PROJECT COMMENTS

PROJECT NUMBER: SP2020-023
PROJECT NAME: Site Plan for 351 Ranch Trail
SITE ADDRESS/LOCATIONS: 315 RANCH TRL, ROCKWALL, 75032

RE: 351 Ranch Trail Site Plan Comment Response Letter

tnp project
RSY20508
sheet
C1.04

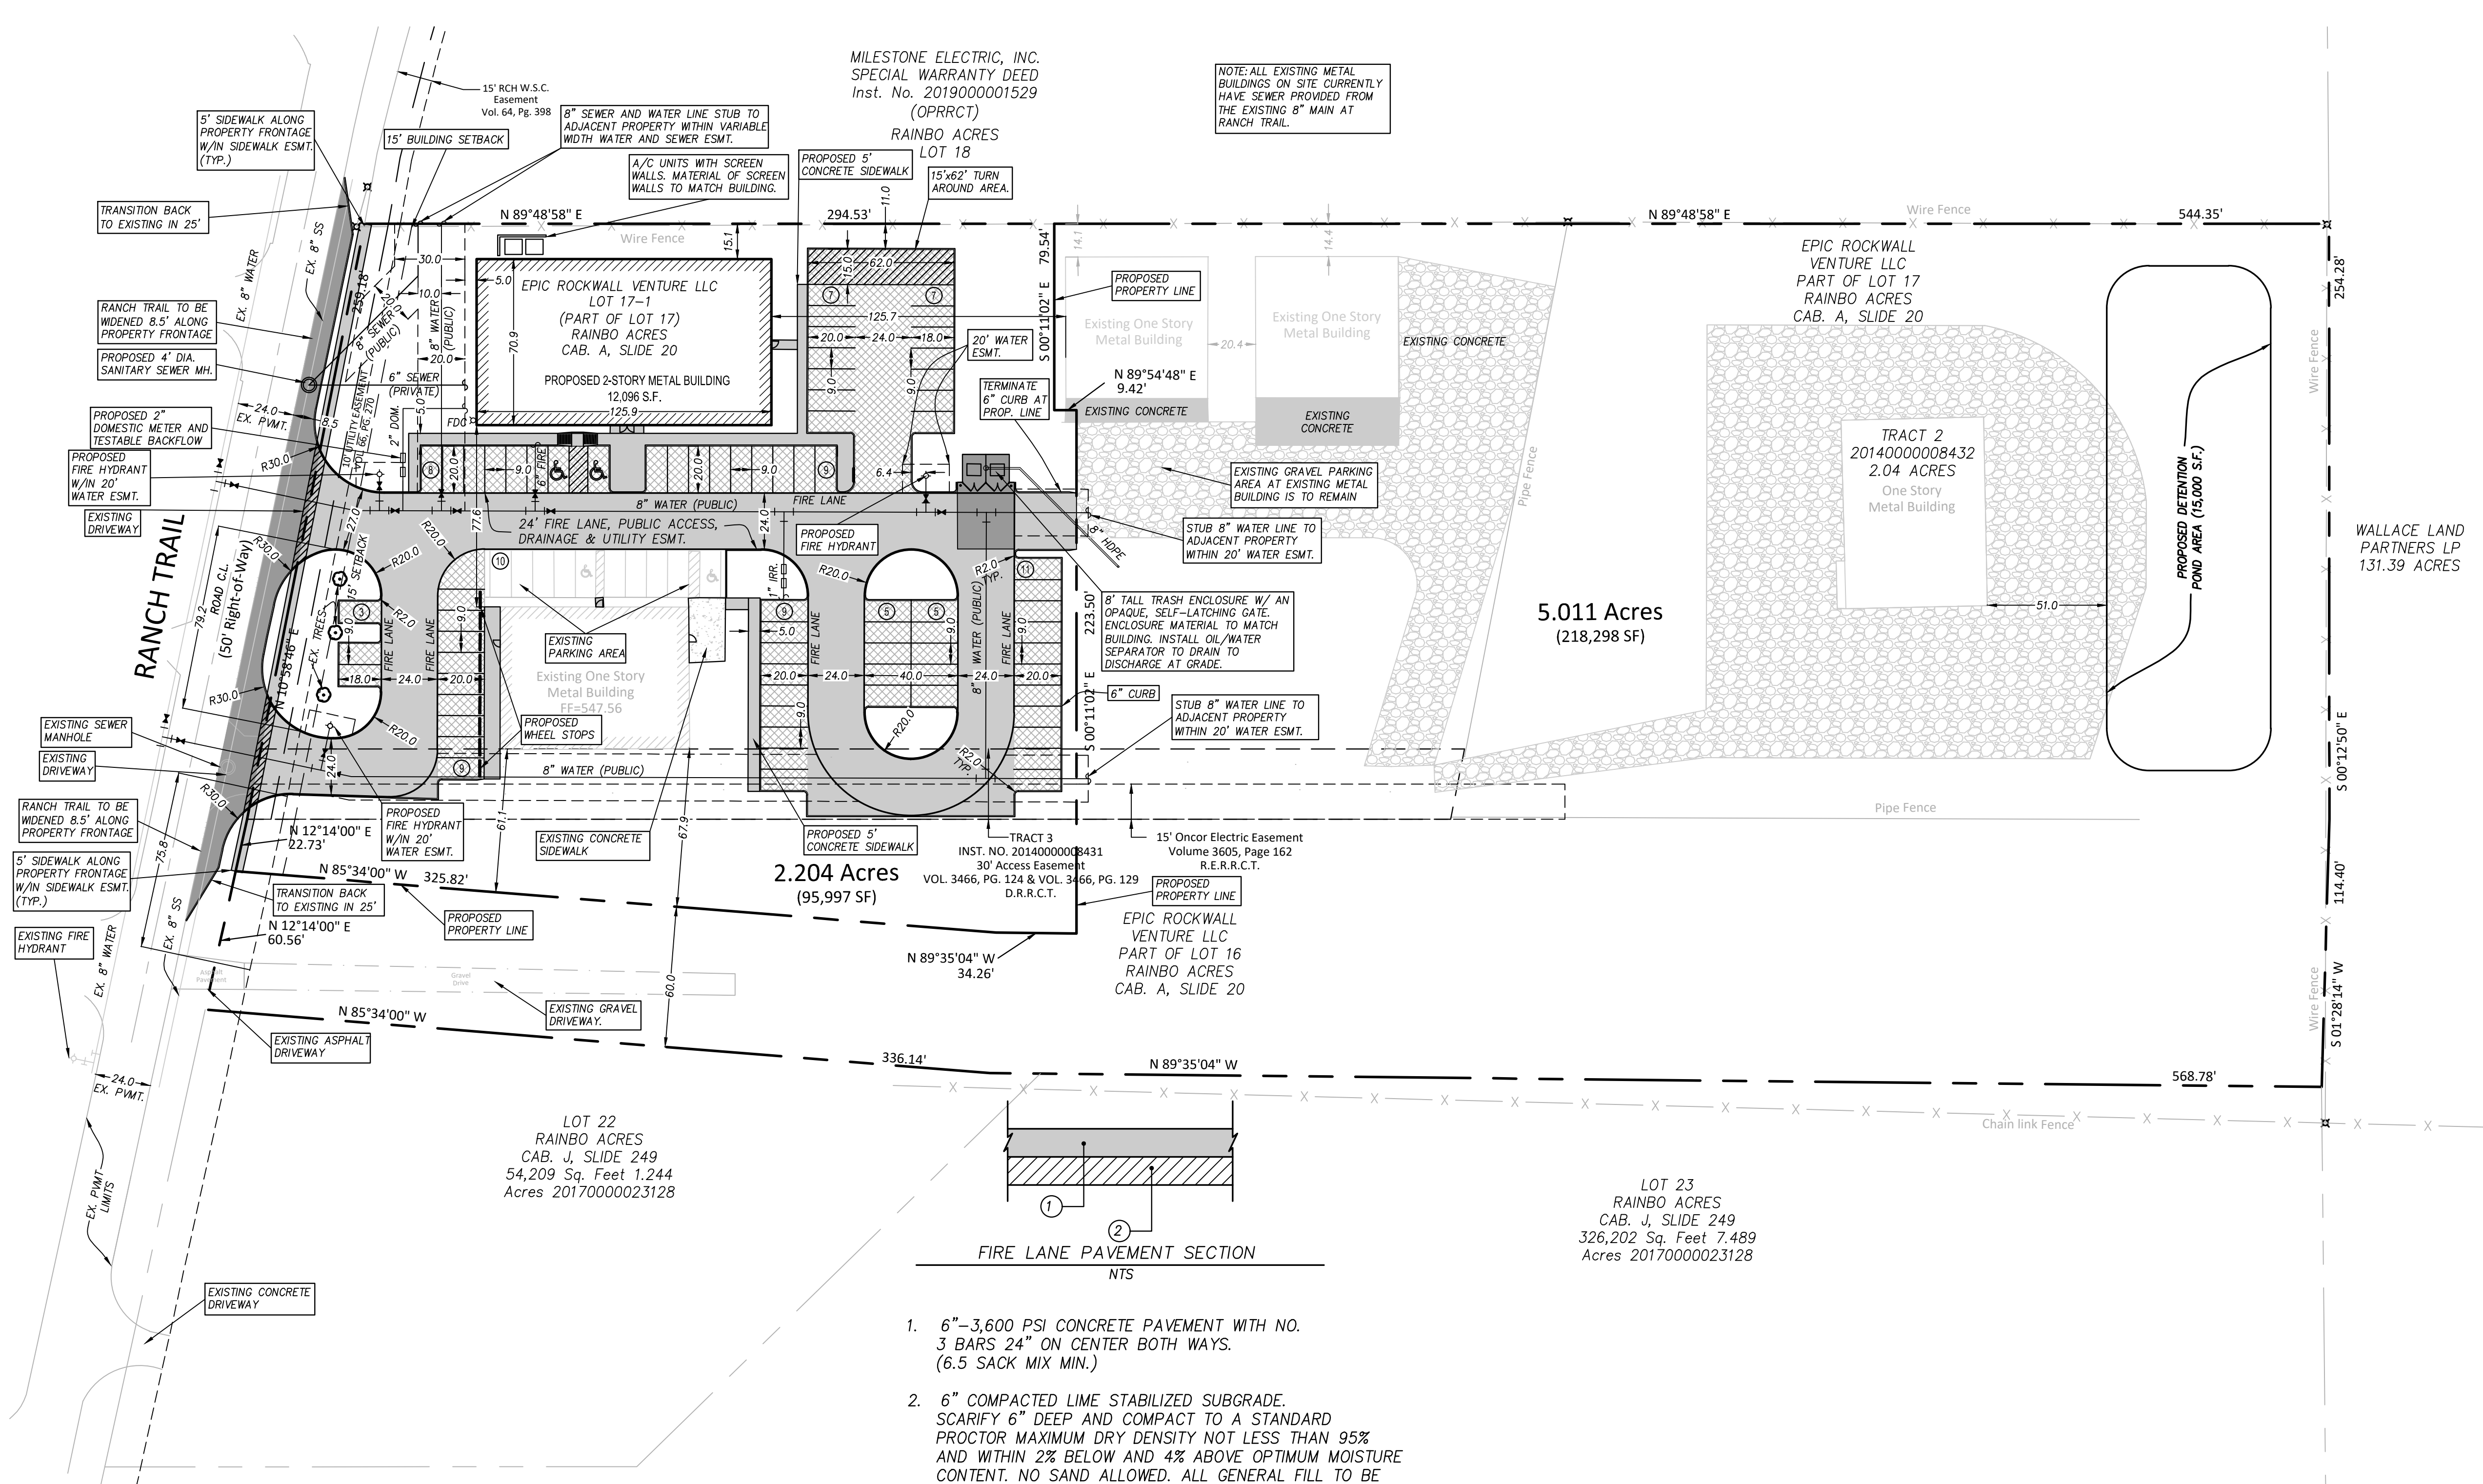
M.7 Site Plan. Please make the following clarifications on the site plan. (§03.04, Art. 11, UDC):

- 1) Correct the address on the title block to indicate '351 Ranch Trail'. (§03.04.A, Art. 11, UDC)
- 2) Indicate the distance between the building and Ranch Trail. (§03.04.B Art. 11, UDC)
- 3) Indicate all easements. Provide a cross access easement to the property to the east/rear. (§03.04.B Art. 11, UDC)

- Fire lane to be 24' wide with 20' radii (or 30' rad. depending on height). (m)			
- Parking to be 20'x9' (i)			
- Verify ROW width. Must have 30' dedicated from the Center line of Ranch Trail. Sidewalk to be 2' inside the ROW. (m)

- Taper access pavement with on adjacent property to match 24' wide width. (m)			
- Must install 5' sidewalk along Ranch Trail. (i)			
+Water & Wastewater Items:+

- Must bring sewer to all buildings and back lot. (m)			
- 8" water available across Ranch Trl. Must loop 8" waterline in site. Full panel concrete replacement required.

- Sewer Pro-Rata of \$94.41 per acre.
- Fire hydrants to have 5' clearance around (Even from parking spaces) (m)
- No walls in utility esmts (i)

- Dumpster area to drain to oil/water separator or grease trap. (i)
- Must have detention. Manning's "c-value" is for any new impervious areas.
- Detention outfall must reach sheet flow conditions prior to crossing the property line. (i)
- No vertical walls allowed in detention.

1. Correct the address on the title block to indicate '351 Ranch Trail'. (§03.04.A, Art. 11, UDC)
[TNP Response: Title block address has been corrected.](#)
2. Indicate the distance between the building and Ranch Trail. (§03.04.B Art. 11, UDC)
[TNP Response: Added dimension from Ranch Trail right of way to the closest building corner.](#)
3. Indicate all easements. Provide a cross access easement to the property to the east/rear. (§03.04.B Art. 11, UDC)
[TNP Response: A 24' Fire Lane, Public Access, Drainage and Utility Easement is provided.](#)

- Roadway/Paving Items:
 - Fire lane to be 24' wide with 20' radii (or 30' rad. depending on height). (m)
[TNP Response: Noted.](#)
 - Parking to be 20'x9' (i)
[TNP Response: Noted.](#)
 - Verify ROW width. Must have 30' dedicated from the Center line of Ranch Trail. Sidewalk to be 2' inside the ROW. (m)
[TNP Response: An additional 5' of right of way has been provided on the project property.](#)
 - Taper access pavement with on adjacent property to match 24' wide width. (m)
[TNP Response: Tapered pavement section has been added.](#)
 - Must install 5' sidewalk along Ranch Trail. (i)
[TNP Response: 5' sidewalk along Ranch Trail is included 2' inside the dedicated right of way.](#)

- **Water & Wastewater Items:**
 - Must bring sewer to all buildings and back lot. (m)
TNP Response: Sewer line has been extended past east property line to allow for other buildings on adjacent lot to connect. A stub from the proposed manhole will be provided for the adjacent lot connection.

- 8" water available across Ranch Trl. Must loop 8" waterline in site. Full panel concrete replacement required.
TNP Response: 8" proposed water line is looped on site. Full panel replacement requirement has been noted.

- No walls in utility esmts (i)
TNP Response: Noted.
- **Drainage & Detention Items**
 - Dumpster area to drain to oil/water separator or grease trap. (i)
TNP Response: Per the client's request, they would like for the dumpster to be removed from the plan and all buildings will be using "Poly Carts" for trash and recycling. This will be coordinated with the city prior to C/O.

LANDSCAPE PLAN

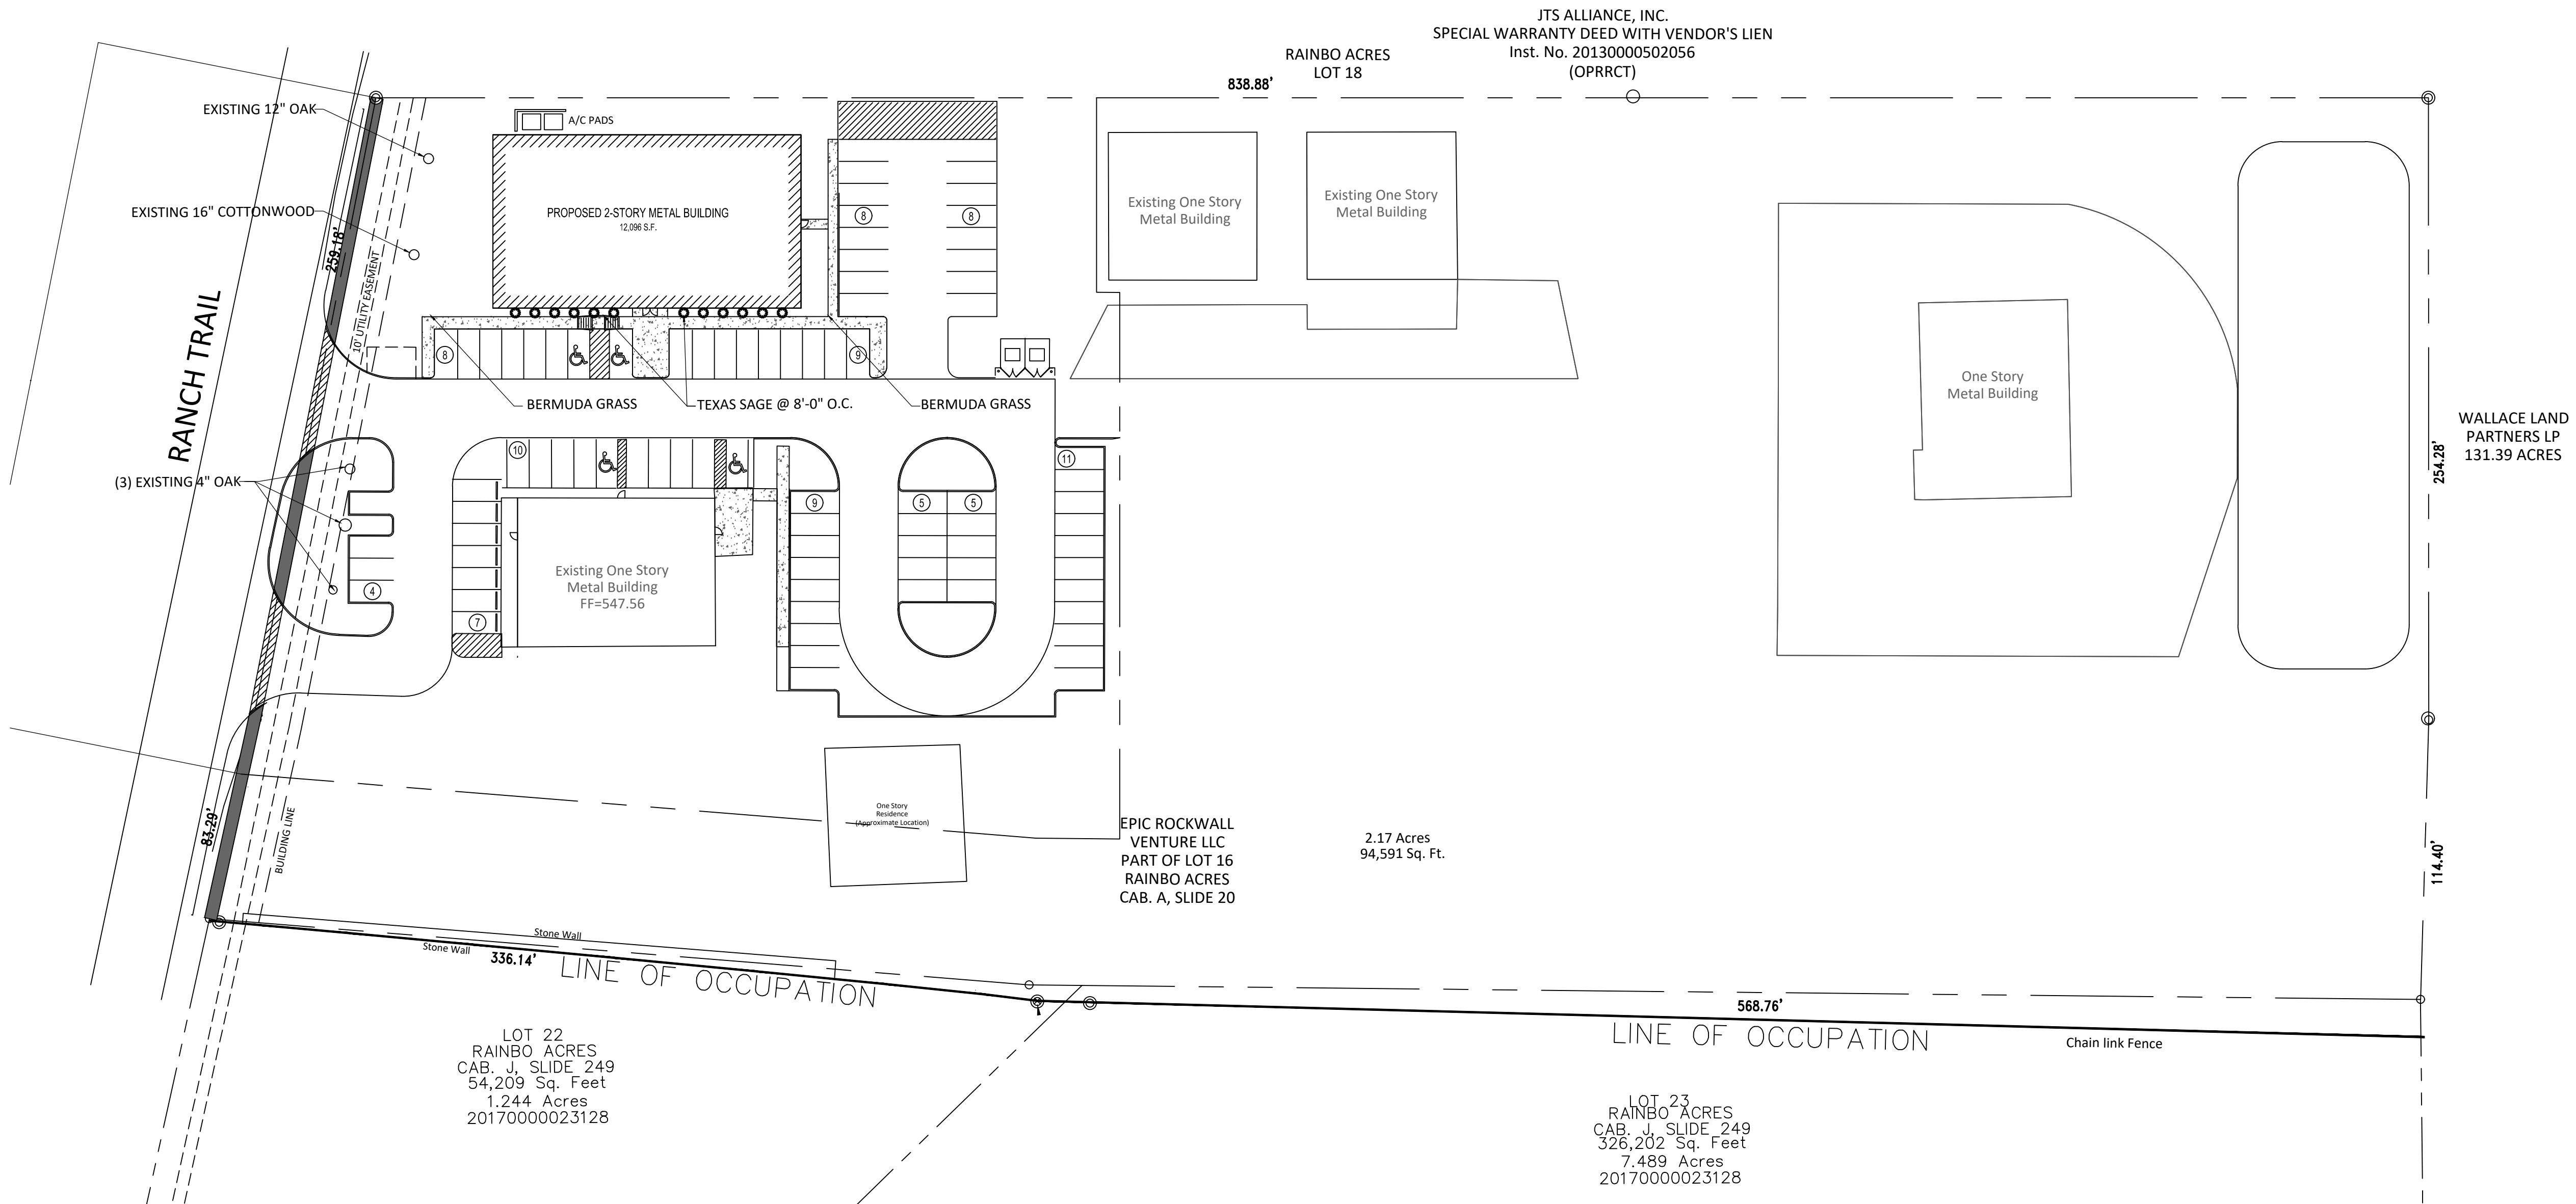
M.8 Landscape Plan. Please make the following clarifications and changes to the landscape plan. (Sec. 2, Art. 08, UDC):

- 1) Provide the same site data information as inserted with the Site Plan: Miscellaneous and Density and Dimensional Requirements of this checklist. (Sec. 2.1 of the Site Plan Checklist)

- 2) Provide a label for the detention area for the site. (Sec. 3.1 of the Site Plan Checklist)
- 3) Provide a standard signature block with a signature space for the Planning & Zoning Chairman and Planning Director on the revised landscape plan. (§03.04.A, Art. 11, UDC)

- 4) Indicate the locations and dimensions of the required landscape buffers. Label the minimum 10-ft landscape buffer along Ranch Trail. (§05.01, Art. 08, UDC)

- 5) Indicate the locations of all existing and proposed landscaping. (§05.03.(B), Art. 08, UDC)
- 6) Identify visibility triangles on all lots for all driveway intersections and public streets. (§01.08, Art. 08, UDC)

- 7) Provide note indicating irrigation will meet requirements of UDC on Sheet No. L1.1. (§5.04, Art. 08, UDC)

- 08/17/2020: 1. Cottonwood would not count towards tree requirements as it is not a protected tree.
 2. Please verify that the parking layout does not trigger parking lot trees based on landscape requirements.
 3. No tree planted within 5' of utility lines
 4. Verify existing trees are not in the visibility triangle

DRAWING NAME:
BUILDING ELEVATION

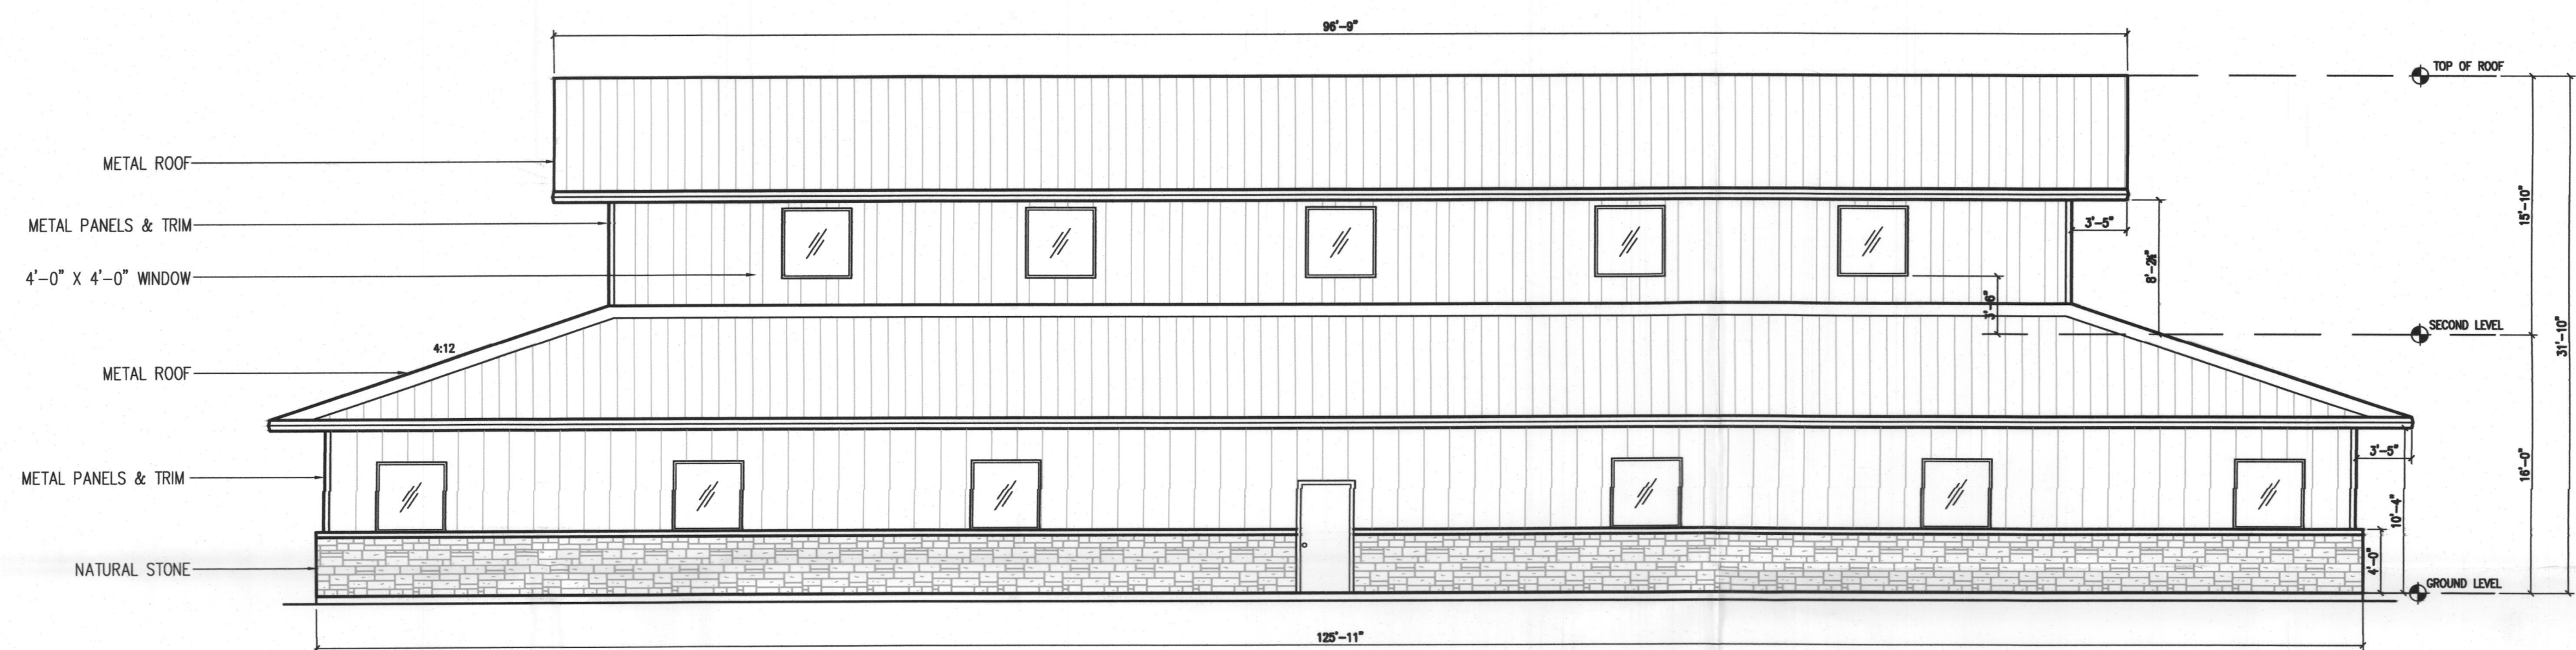
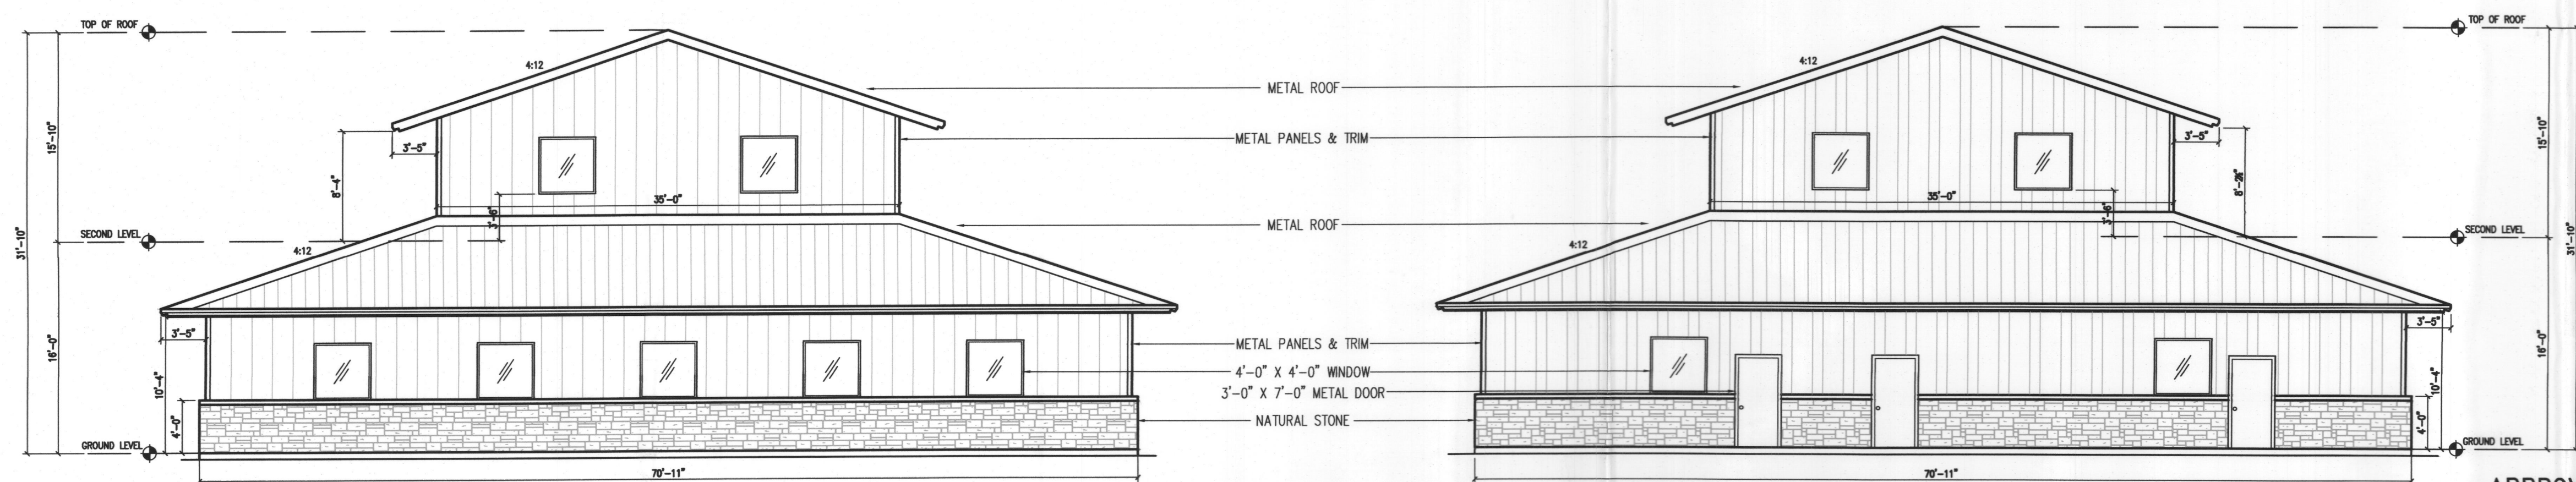
M.10 Building Elevations.

- 1) Provide a standard signature block with a signature space for the Planning & Zoning Chairman and Planning Director on the building elevations for approval. (§03.04.A, Art. 11, UDC)
